Re: SB25-0014 – Hillcamp Trail Filing No. 1 – 3rd Review Comments

Please see the Applicant Team's comment responses to the third submittal comments made on February 11, 2026. The comment responses are in **blue**.

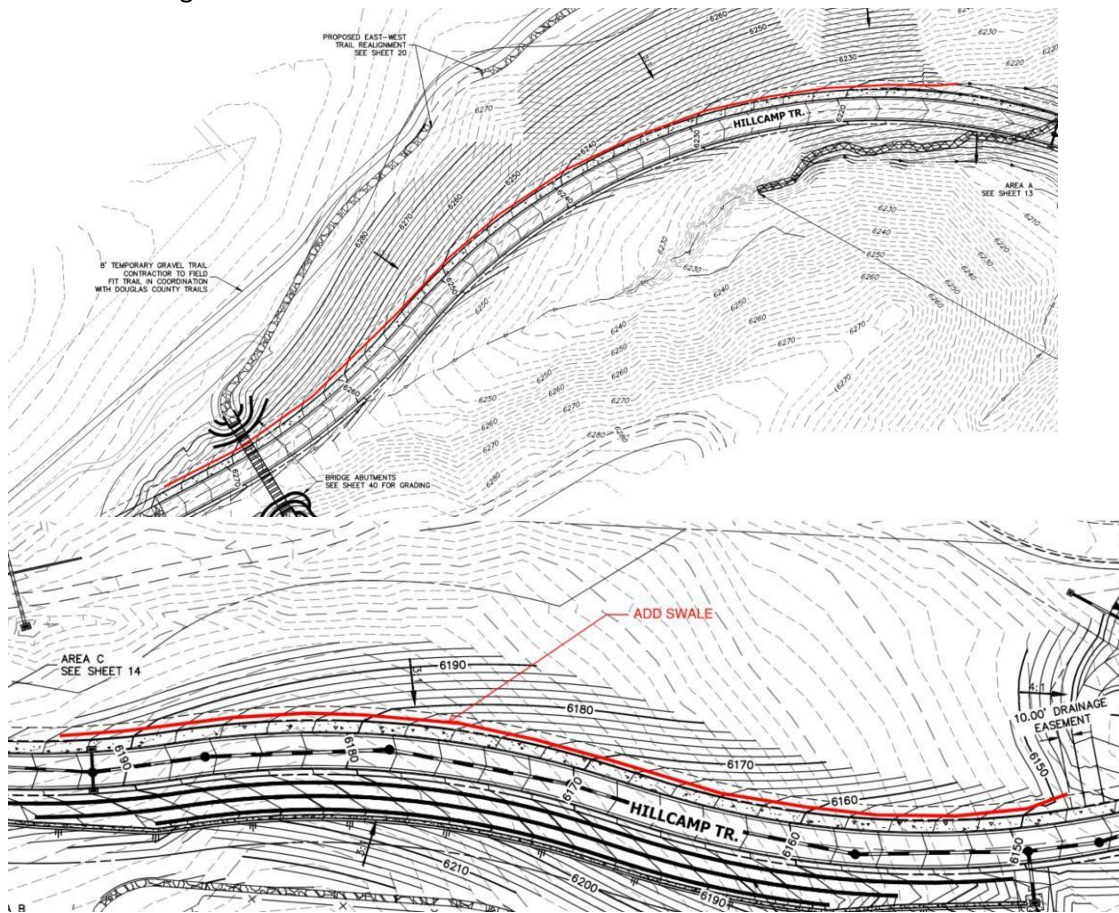
4. Although the pond retrofit has capacity for the 500-year storm event, a dedicated emergency spillway is necessary in the event of clogging or a larger storm event. Please also include details on the spillway with the other detention pond details.

Applicant Response: The pond is no longer proposed.

14. Sheet 38:

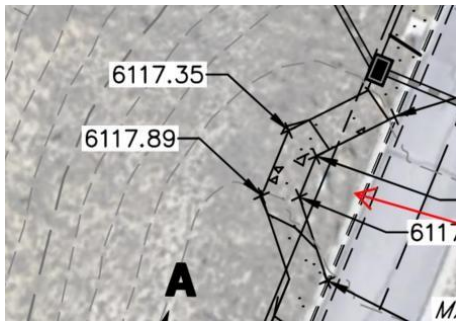
- a. Text has been cut off for the Outlet Structure Profile View at left viewport.
- b. Section A-A calls out the plate at 6" above the 18" invert, however, the drainage design spreadsheet calls out 18" above invert, please verify and update as needed.
- c. Section B-B calls out 15/16" diameter holes, however, the drainage design spreadsheet uses 7/8". Please verify and update as needed.

Applicant Response: The pond is no longer proposed.
